RE: Whirlwind Mine, Permit No. 2007-044, Technical Revision (TR-2), Adequacy Review-1

Re: Response to Request for Assistance, Whirlwind Mine, Permit No. M-2007-044, Technical Revision 2 – Water Treatment System Add-on

**Subject: Whirlwind Mine (Permit No. M-2007-044)
TR-2**

Figure 1: Process flow diagram, copied from Appendix H2

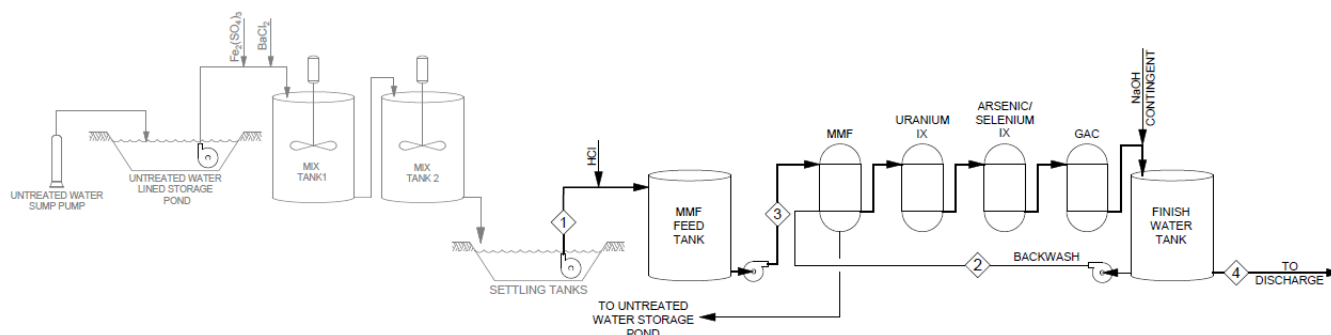
The proposed add-on system is thoroughly described in the material submitted with TR-2. In summary, the system takes treated water from the existing settling/polishing tanks, and passes it in series, through

sand filters (to remove suspended solids), a strong base anion exchange resin (to remove uranium), a second ion exchange resin (to remove arsenic and selenium), and activated carbon (to remove organic compounds). The effluent is treated with sodium hydroxide, as necessary, to raise the pH prior to discharge, see Figure 1.

Detailed design drawings are given for the add-on system, (and aspects of the existing system), which would greatly assist a new operator in taking over responsibility for running the system in case that were to be necessary in the future. The detailed drawings show redundancy of critical parts of the system, as well as components necessary for maintenance.

I have no adequacy concerns about the material submitted with TR-2.
